Intersection ID: 24095	Main Street: LIVINGSTON_MILL_RD	Cross Street: RED_WINE_CT	Location:	NE
ADA ID: A3A91914BB1D	Ramp Type: PerpDiag	Initial Pass/Fail: Fail	Overall Compliance: No	Severity Score: 33.75

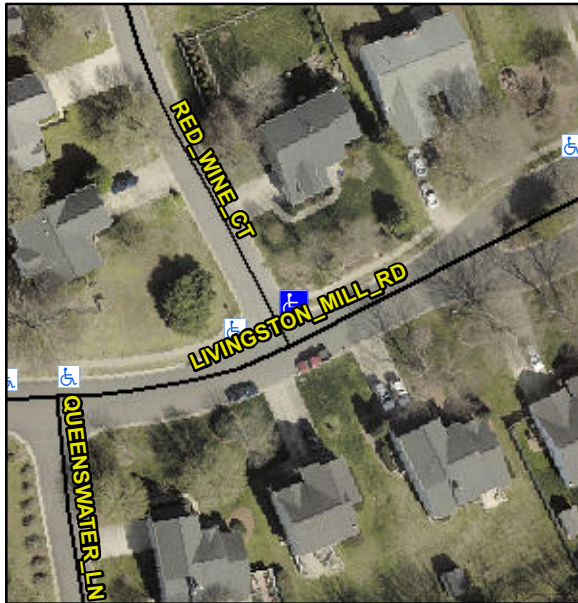
**R304.5.1, R304.2.2, R304.5.3**

Compliance	Description	Data	Compliance	Description	Data
N/A	Ramp Length (in)	94.0	No	Ramp Slope (%)	9.0
No	Ramp Width (in)	46.0	No	Ramp XSlope (%)	5.4
N/A	Flare Type LT	N/A	N/A	Flare Type RT	N/A
N/A	Flare Slope LT (%)	N/A	N/A	Flare Slope RT (%)	N/A
N/A	Flare Traversable LT?	N/A	N/A	Flare Traversable RT?	N/A
N/A	Landing Length (in)	N/A	N/A	DWS Provided?	N/A
N/A	Landing Width (in)	N/A	N/A	DWS Contrast?	N/A
N/A	Landing Slope (%)	N/A	N/A	DWS Length (in)	N/A
N/A	Landing X Slope (%)	N/A	N/A	DWS Full Width?	N/A
N/A	Landing Curb? (Y/N)	N/A	N/A	DWS Offset (in)	N/A
N/A	Shared Landing?	N/A			
N/A	Gutter Ponding?	N/A	N/A	Gutter Slope (%)	N/A
N/A	Gutter Lip Ht (in)	N/A	N/A	Gutter X Slope (%)	N/A
N/A	Painted X Walk1?	No	N/A	Painted X Walk2?	No
	X Walk 1 Direction	To W		X Walk 2 Direction	To S
N/A	X Walk 1 Width (in)	N/A	N/A	X Walk 2 Width (in)	N/A
	X Walk 1 Slope (%)	1.2		X Walk 2 Slope (%)	3.0
	X Walk 1 X Slope (%)	2.3		X Walk 2 X Slope (%)	0.8

**Remove & Replace Curb Ramp With Two New Directional Ramps or Equivalent.**
